Site Accessibility Evaluation

Homestead Ranch Regional Park

Accessibility Evaluation

Inspection Date: 01/30/2018

Parking Area

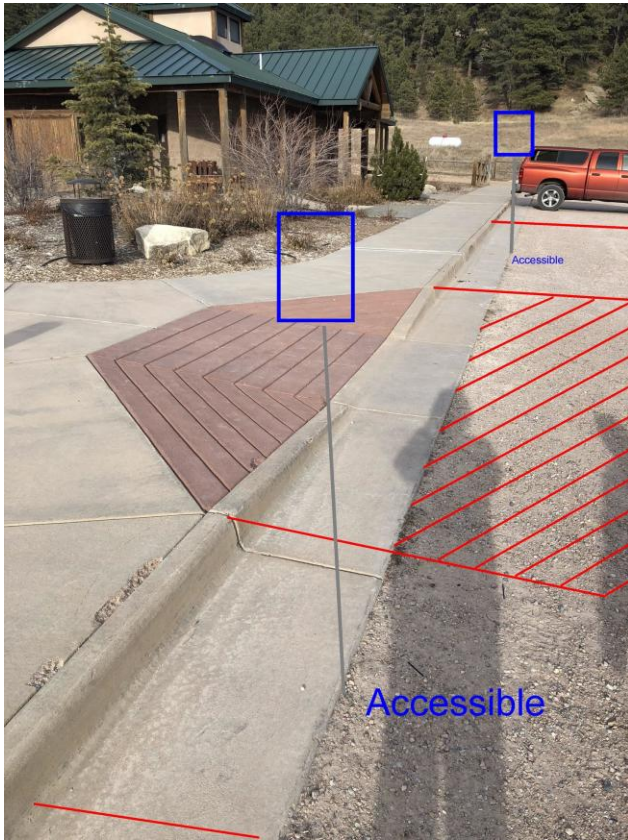
There are no accessible parking stalls.

No accessible aisles
nor accessible stalls.

Based on 9 ft - width parking stall measurements it was determined that there are 50 stalls available, which would require two accessible parking stalls. Recommend making both Van accessible w/proper international symbol of accessibility signage. This means that the area that needs to be paved would include two accessible parking stalls with accessible aisle leading directly to pedestrian ramp.

Curb Ramp from Main Parking Lot

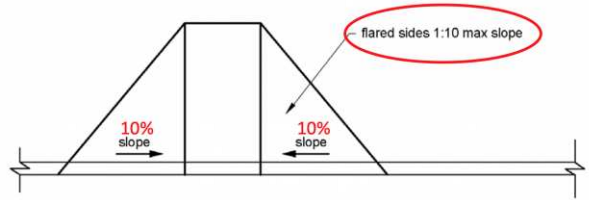
The curb ramp side flares are too steep.

Ramp flares exceed the maximum allowed. Left 12.19% and Right 11.13%

Reconstruct flares/ramp to meet the maximum 1:10 slope.

Main Path of Travel to Restrooms and Play Areas

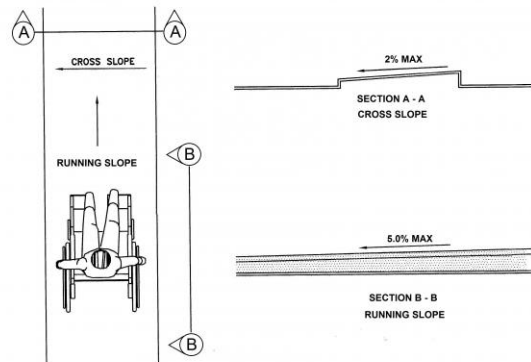
The accessible route contains running slopes greater than 5 percent and cross slopes greater than 2 percent across the width of the walk and has not been constructed as a ramp (i.e. handrails, wheel guides, etc.).

Some sections of the route exceed the maximum running and cross slope allowed.

Replace and/or adjust each section to meet ADA requirements.

Women's Restroom

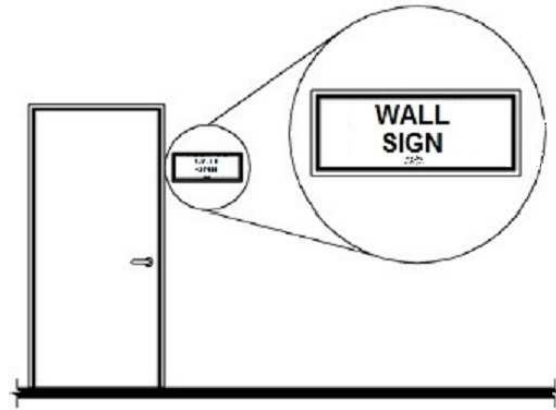
The tactile sign is incorrectly installed behind acrylic polymer.

Sign installed behind acrylic polymer

Remove acrylic polymer.

Women's Restroom

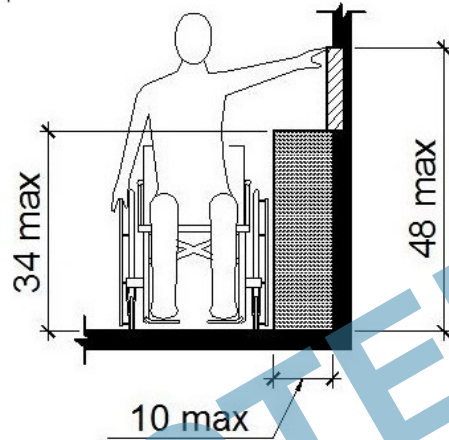
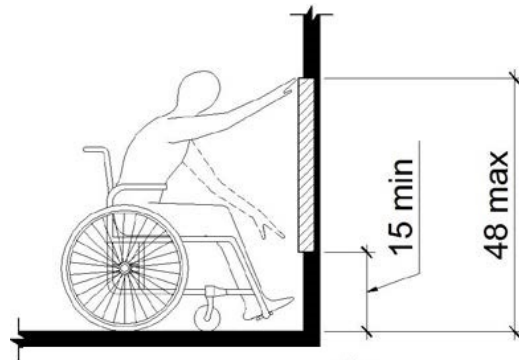
The coat hook is installed greater than 48 inches above the finished floor.

Coat hook is installed at 60 inches above finished floor.

Lower coat hook 13 inches minimum or install another coat hook not to exceed a maximum height of 48 inches above finished floor.

Women's Restroom

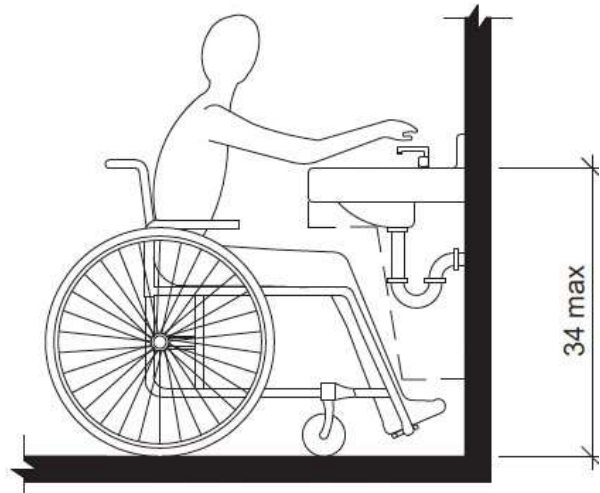
The top rim of the lavatory is too high.

Lavatory installed at 35 inches.

Lower to 2010 ADAS of 34 inches maximum above finished floor.

Women's Restroom

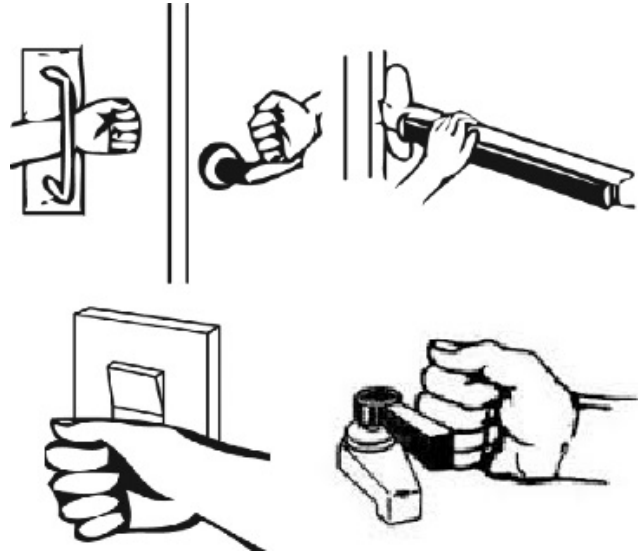
The force required to operate the element exceeds the maximum.

Flush control force to operate is set at 10 lbs.

Adjust flush control force to activate at 5 lbs maximum force or less.

Women's Restroom

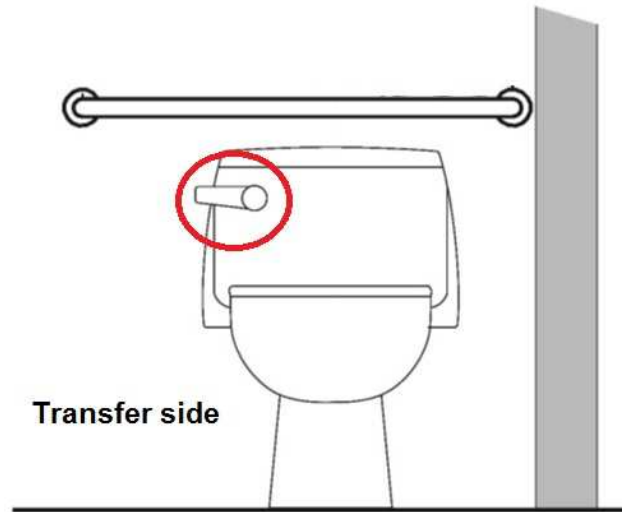
The flush handle is located on the wrong side of the toilet.

Flush control not located on open side of water closet.

Install flush control on open side of water closet no more than 44 inches above finished floor.

Women's Restroom

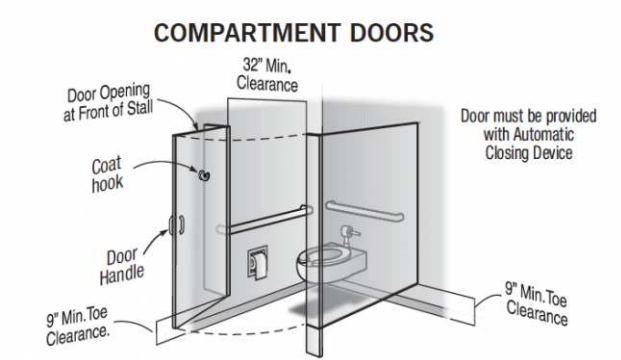
The compartment door is not self closing.

Not self closing.

Adjust or install automatic closing hinges.

Women's Restroom

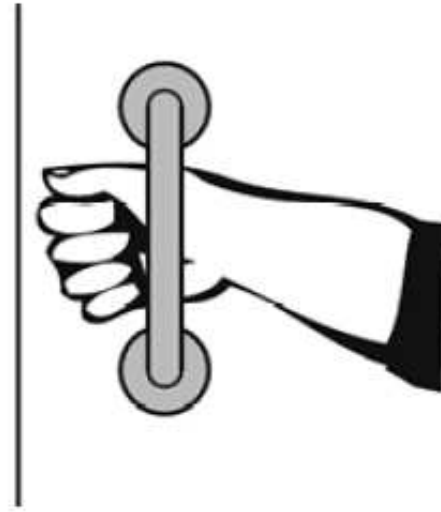
The water closet compartment door is missing a loop handle on the inside.

No loop handle installed.

Install loop handle on inside of toilet compartment door.

Women's Restroom

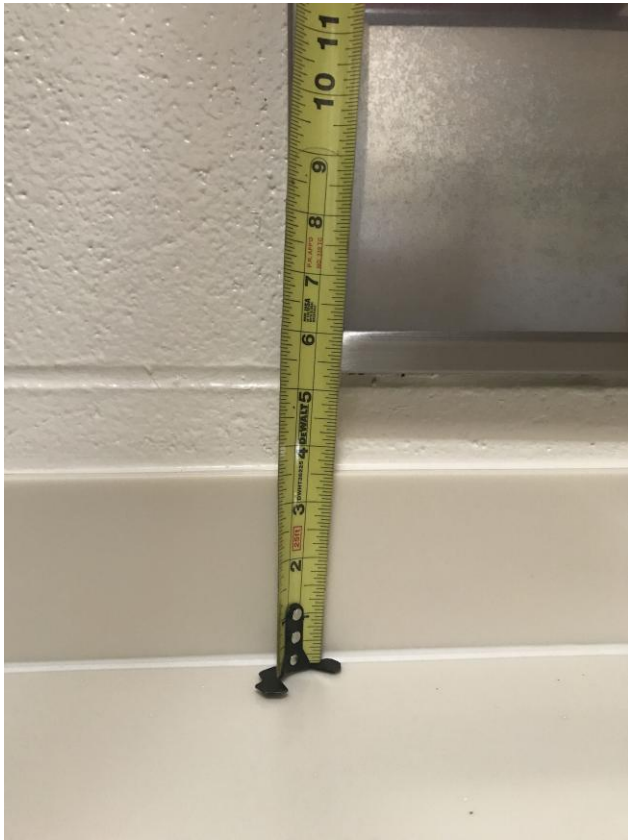
The mirror is mounted too high.

41 inches above
finished floor

Lower mirror to a maximum of 40 inches above finished floor measured to the bottom edge of the reflective surface. Recommend lowering mirror 1.5 inches.

Men's Restroom

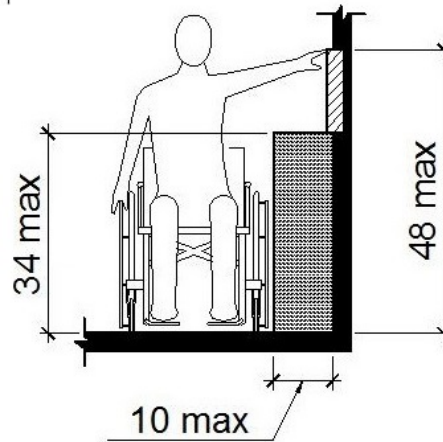
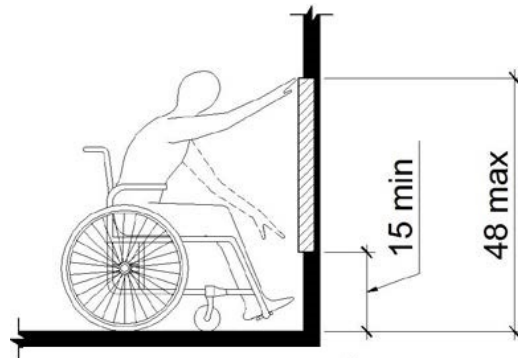
The coat hook is installed greater than 48 inches above the finished floor.

Coat hook is installed at 60 inches above finished floor.

Lower coat hook 13 inches minimum or install another coat hook not to exceed a maximum height of 48 inches above finished floor.

Men's Restroom

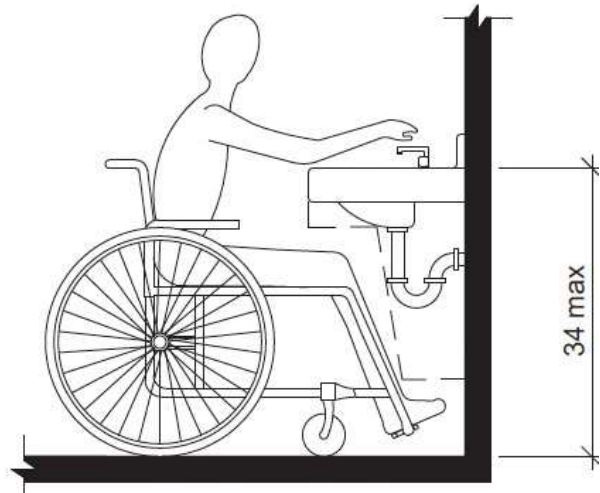
The top rim of the lavatory is too high.

Lavatory installed at
35 inches.

Lower to 2010 ADAS of 34 inches maximum above finished floor.

Men's Restroom

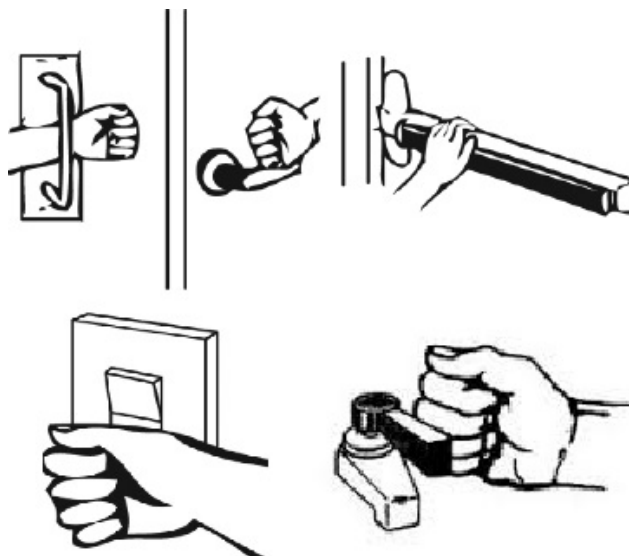
The force required to operate the element exceeds the maximum.

Flush control force to operate is set at 17 lbs.

Adjust flush control force to activate at 5 lbs maximum force or less.

Men's Restroom

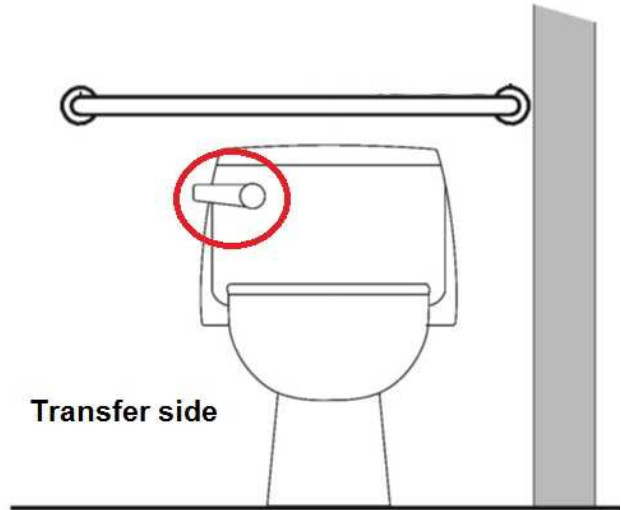
The flush handle is located on the wrong side of the toilet.

Flush control not located on open side of water closet.

Install flush control on open side of water closet no more than 44 inches above finished floor.

Men's Restroom

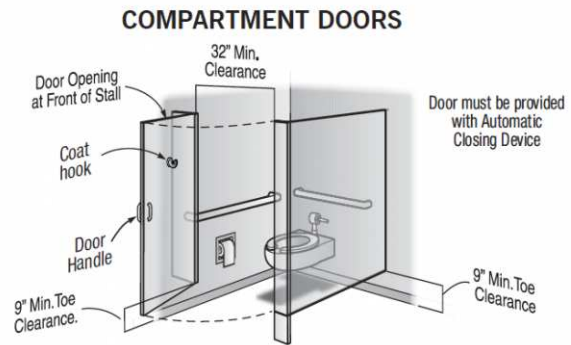
The compartment door is not self closing.

Not self closing.

Adjust or install automatic closing hinges.

Men's Restroom

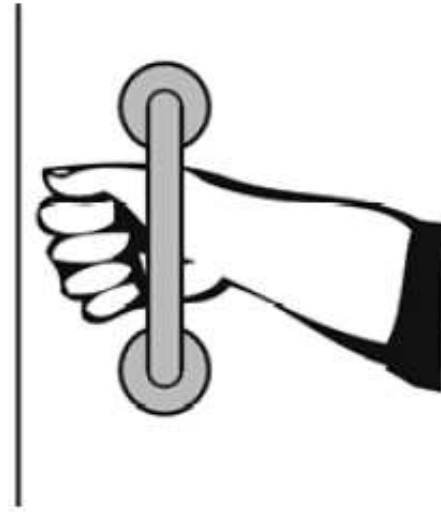
The water closet compartment door is missing a loop handle on the inside.

Compartment door
missing inside loop
handle

Install loop handle on inside of toilet compartment door.

Men's Restroom

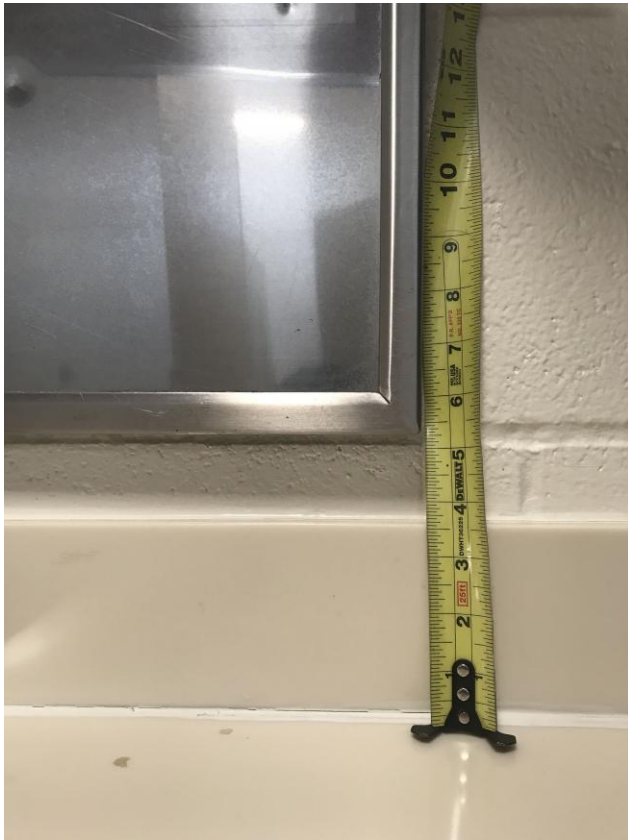
The mirror is mounted too high.

40.5 inches above
finished floor

Lower mirror to a maximum of 40 inches above finished floor measured to the bottom edge of the reflective surface. Recommend lowering mirror 1 inch.

Play Area

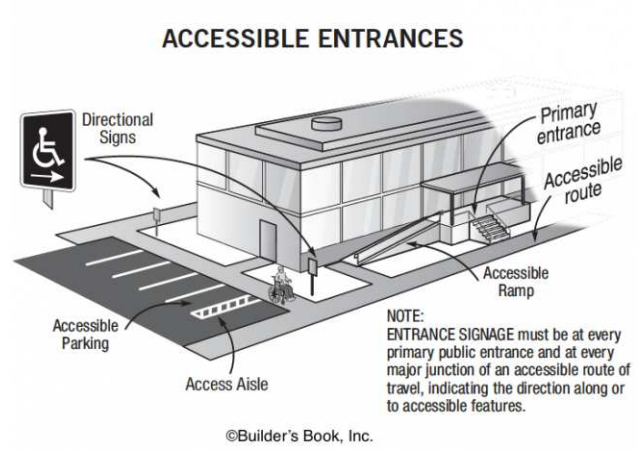
There is no accessible route to the play area.

No accessible route.

Install accessible ramp to play area.

Upper Play Area

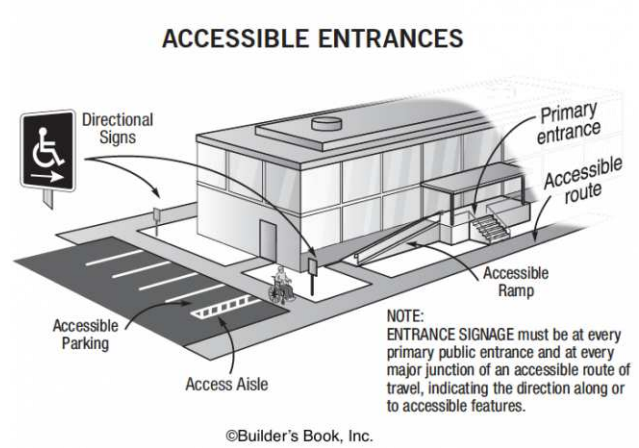
There is no accessible route to the play area.

No accessible route.

Install accessible ramp to play area.

Drinking Fountain

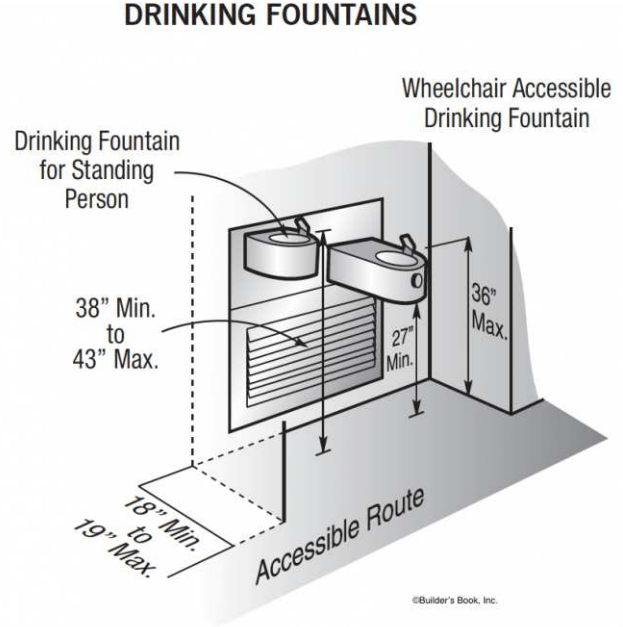
The drinking fountain is not accessible.

Replace drinking fountain with unit that provides knee clearance and clear floor space for a forward approach centered on the unit.
